AB APPARELS LTD (extension)

225, SINGAIR ROAD, HEMAYETPUR, SAVAR
(23.790530, 90.265082)

12th September 2021

COLUMN NOS.	BELOW GROUND LEVEL	GROUND FLOOR	1ST FLOOR	2ND FLOOR	3RD FLOOR - ROOF
LC1

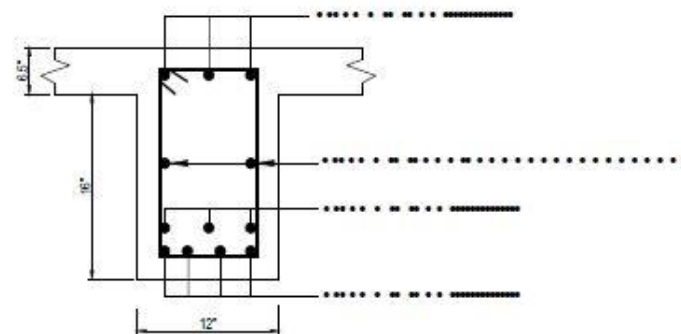
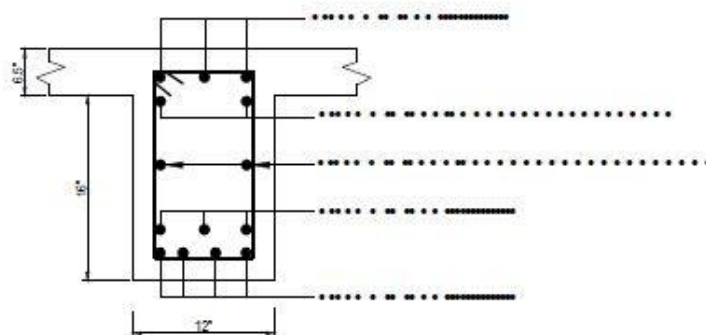
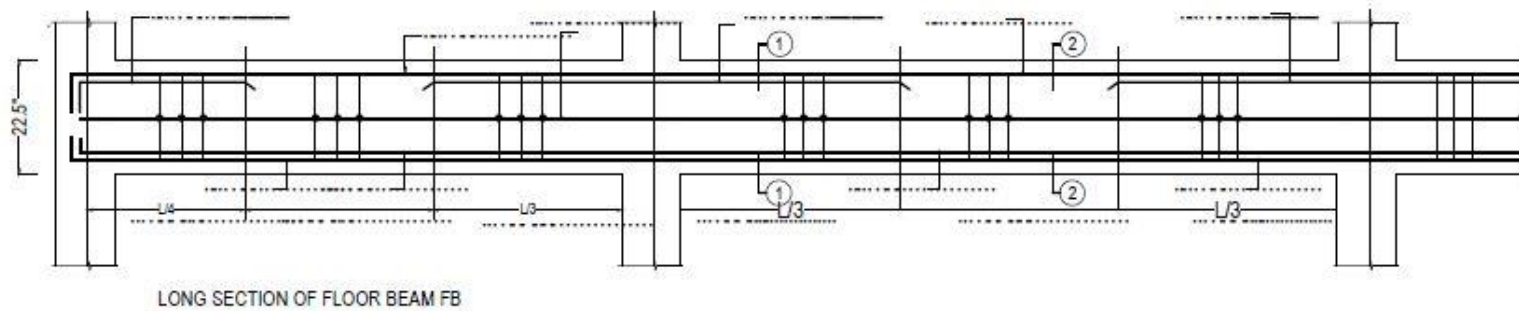
40-rebar are shown for column LC-1 at 3rd floor (existing roof)

36-rebar at grid L-2

38-rebar at grid B1-9A

40-rebar are shown in schedule for column LC-1 at 3rd floor (current roof), but 36, 39, 38 rebar found in different locations. Factory engineer is required to update the as-built structural drawing.

Roof

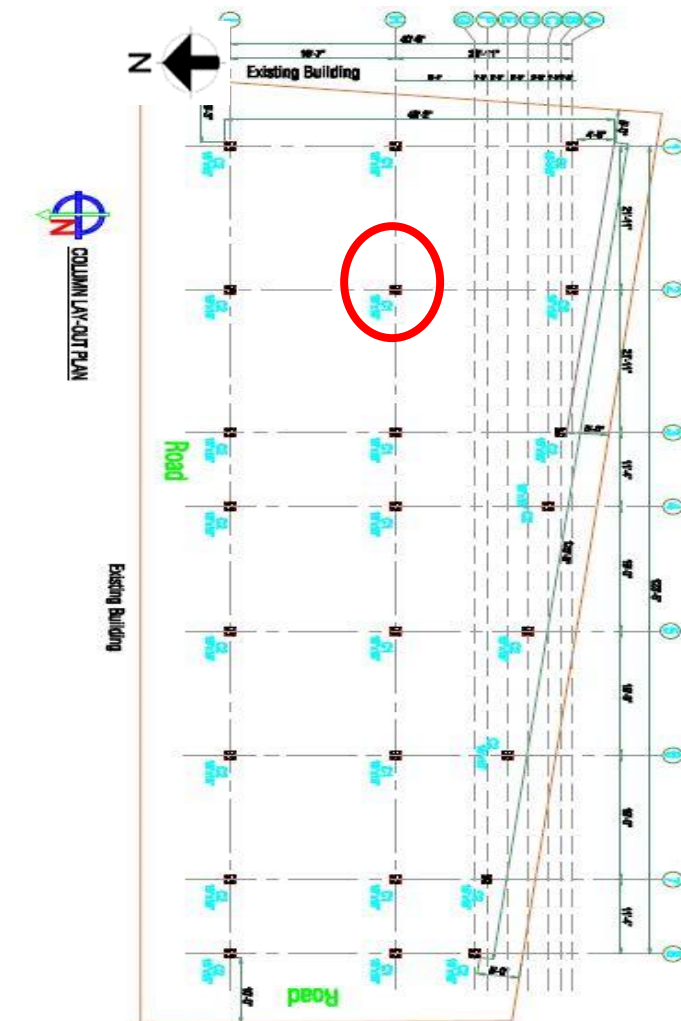
Parapet/railing was missing at several location on roof and staircase

Factory is required to provide parapet/railing at all locations of roof and staircase to avoid possible falling hazard.

Front view

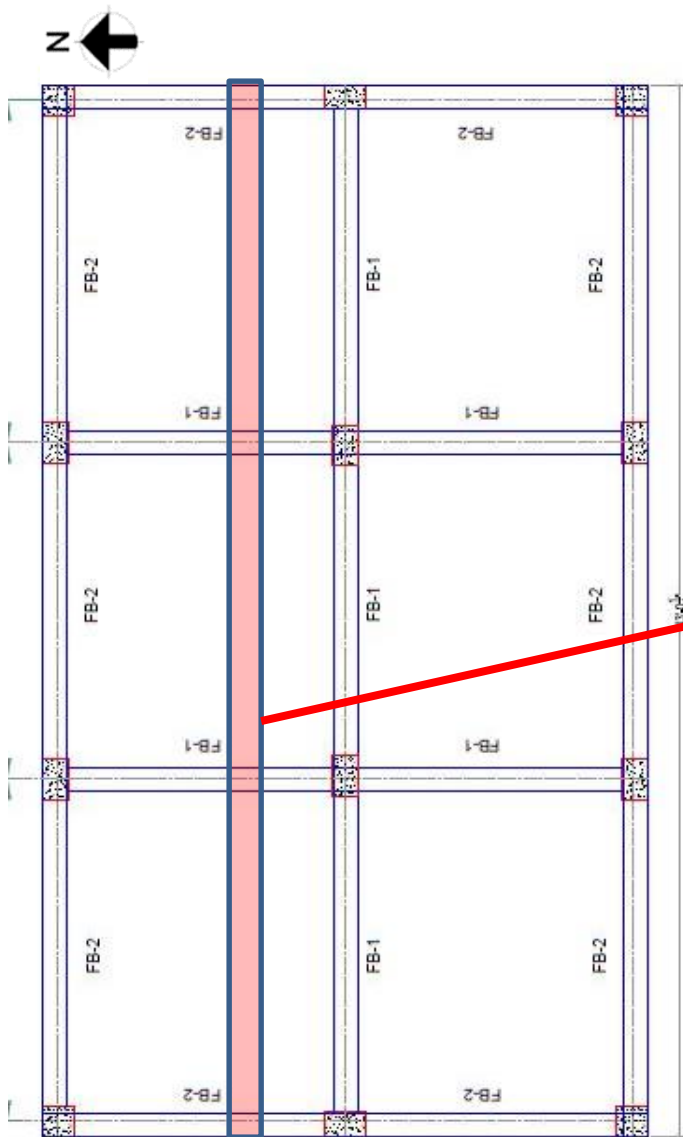
As per BNBC, every building or structure designed shall have its design documents prepared in accordance with the provision of Section 1.9.1. The design document shall include a design report, and a set of structural drawings, which shall be prepared in compliance with section 1.9.1.1 and section 1.9.1.2 as per BNBC. At the time of inspection, no design report was available which is required to be prepared in compliance with section 1.9.1.1 (part-6, BNBC).
